1984 - 1986 Corvette: Service Bulletin: Window Regulators - Replacement

Number: REISSUE 86-17

Subject: WINDOW REGULATORS

Model and Year: 1984-1986 CORVETTE

WINDOW REGULATOR ASSEMBLY

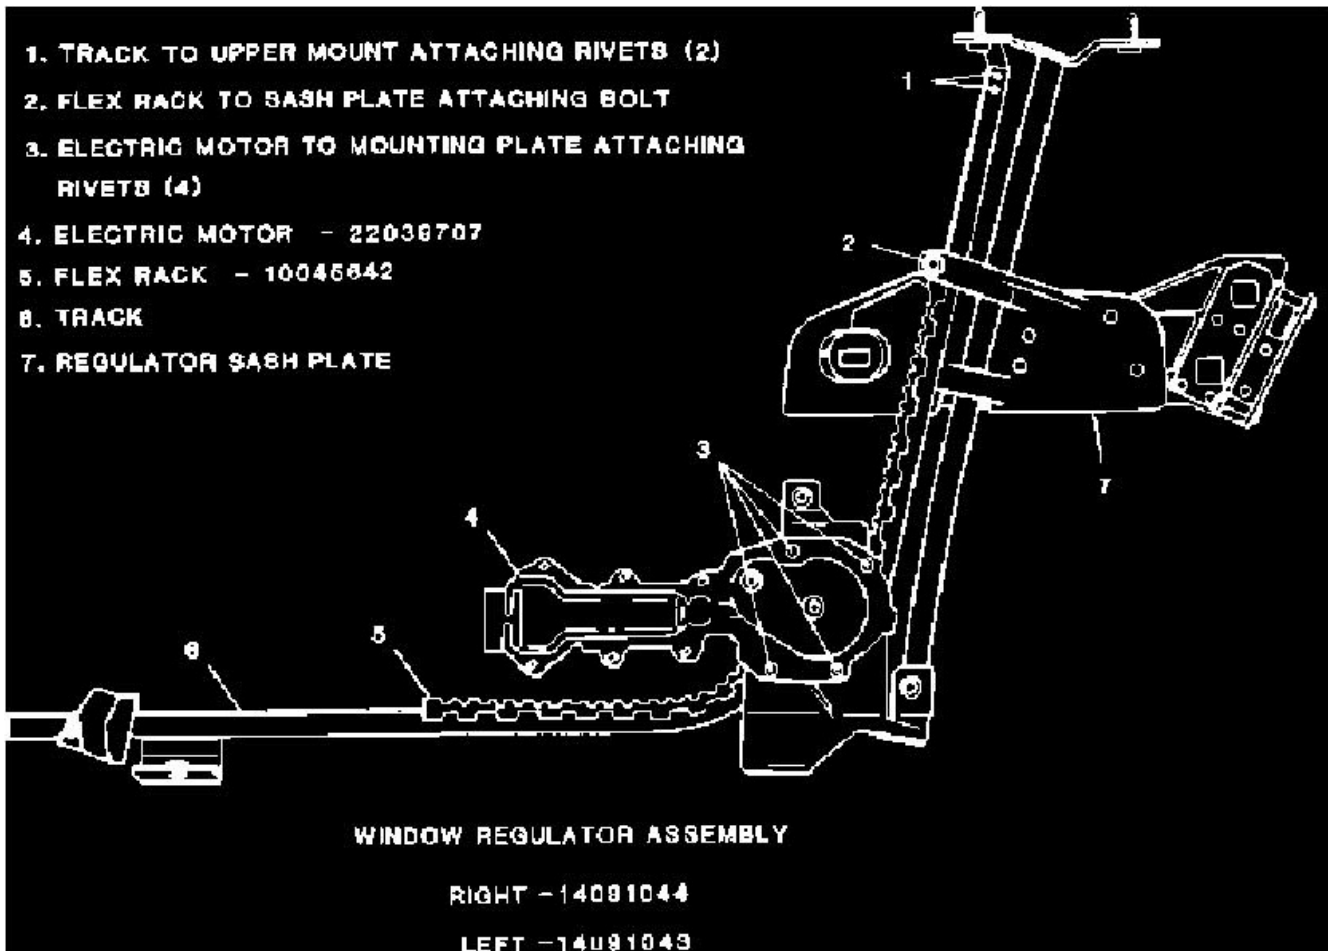
This bulletin contains part numbers and procedures for the replacement of the electric motor and plastic flex rack of the window regulator assembly (Items 4 and 5, Figure 1).

Regulator conditions encountered on vehicles built prior to September, 1984 or that have flex rack tracks which are not chrome, (Item 6, Figure 1) but are yellow or gold in color, or dull metal finish, require replacement of complete regulator assembly.

Conditions encountered on vehicles built after August, 1984 or regulators with chrome flex rack tracks (Item 6, Figure 1) may be repaired with component parts (electric motors and or revised flex racks, Items 4 and 5,

Figure 1).

1. Remove regulator assembly from door and place on a clean work surface.
2. Using an electric drill. motor and 4mm (5/32") drill bit, drill out four (4) attaching rivets that retain the electric window motor to the 1986 Chevrolet Corvette V8-350 5.7L Copyright © 2006, ALLDATA 8.80 Page 2 lower mounting plate (location 3, Figure 1).

3. Remove the motor from the regulator assembly and transfer the plastic drive gear to the new motor.
4. Clean the lower mounting plate of all metal shavings prior to motor installation.

5. Apply lubricant (GM P/N 1052349 or equivalent) to the drive gear, flex rack, track and gear housing on the lower mounting plate.
6. Install the new motor to the mounting plate using four (4) 4 mm X 10 mm (5/32" X 3/8") rivets (location 3, Figure 1).

2. Using an electric drill motor and 4mm (5/32") drill bit, drill out the two (2) track to upper mounting plate attaching rivets (location 1, Figure 1).

3. Remove the Allen head type bolt (location 2, Figure 1) retaining the flex rack to the regulator sash plate. It will be necessary to hold the attachment nut on the underside of the sash plate to prevent it from rotating.

4. Lift track away from upper mounting plate and carefully pull track away from guide tube in order to disengage the flex rack and track from the sash plate opening at location 2, Figure 1.

9. Locate the flex rack and track into the sash plate opening at location 2, Figure 1. Apply Loctite Thread Sealer to the bolt threads prior to reinstalling the Allen type bolt at location 2, Figure 1 to prevent loosening from vibration.

10. Locate and fasten track to the upper mounting plate using two (2) 4mm X 10mm (5/32" X 3/8") rivets (location 1, Figure 1).
11. Using an external power source, operate the regulator to insure quiet, free operation.
